SUNDRY NOTICES AND REPORTS ON WELLS
Do not use this form for proposals to drill or to re-enter an abandoned well. Use Form 3160-3 (APD) for such proposals.

PLUG AND ABANDONMENT PROCEDURE

Ute Mountain Tribal D 3

Conditions of Approval - Notice of Intent to Abandon:

Proposed P&A

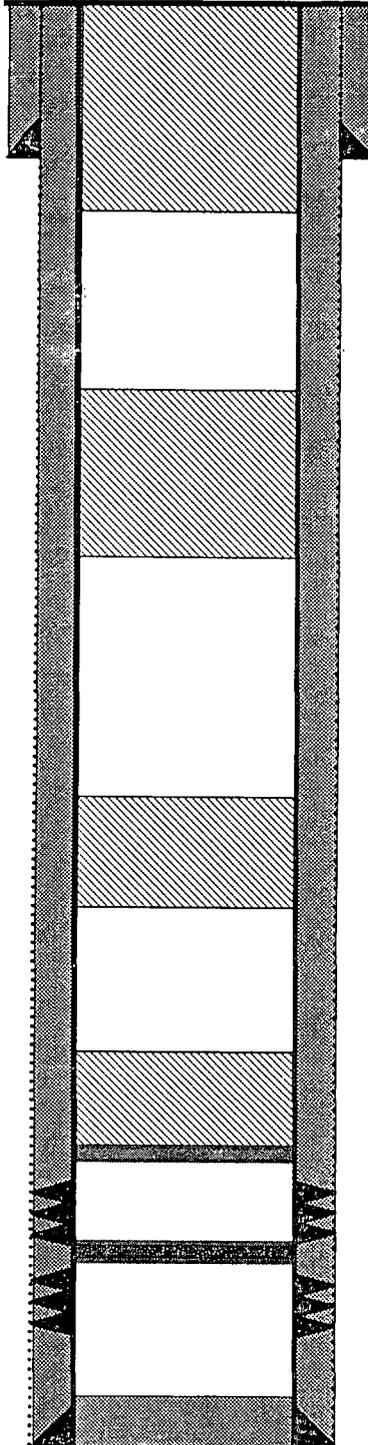
- 6d. Tag plug #2.**
7. The well must be filled with a wellbore mud sufficient to stabilize the wellbore. In the absence of any formation pressure data provided by the operator, this mud will have a minimum weight of **9 ppg**. The mud must be left between all plugs.
